## SERVICE BULLETIN

Reference number:	SB-11-1007	Issued: 27 February, 2018
Subject:	DB11 Bracket for the Paddle-Shift Assembly	
Model(s):	DB11 V12	
VIN Range:	Up to 18.5MY vehicles	
Applicable to:	All Dealers	
Distribute to:	After Sales Manager Executive Manager Service Manager Sales Manager	Warranty Staff Technician(s) Parts Staff

Figure 1

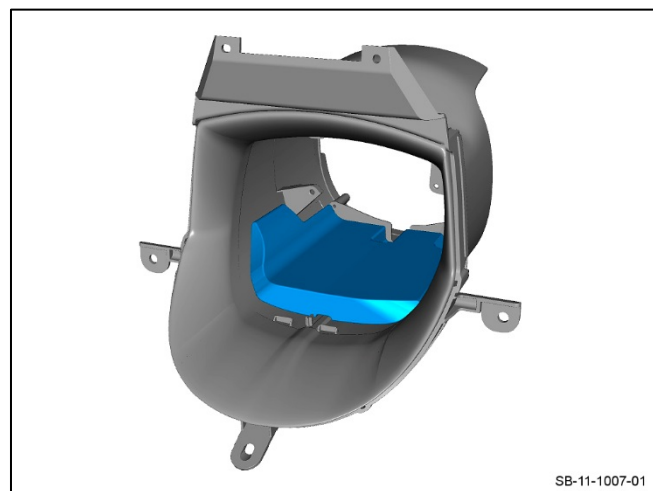
**Note:** *The old steering-column cowl has a foam part (refer to Figure 1). The new steering column cowl does not need a foam part. When you remove the old steering column cowl, do not install the foam to the new steering column cowl.*
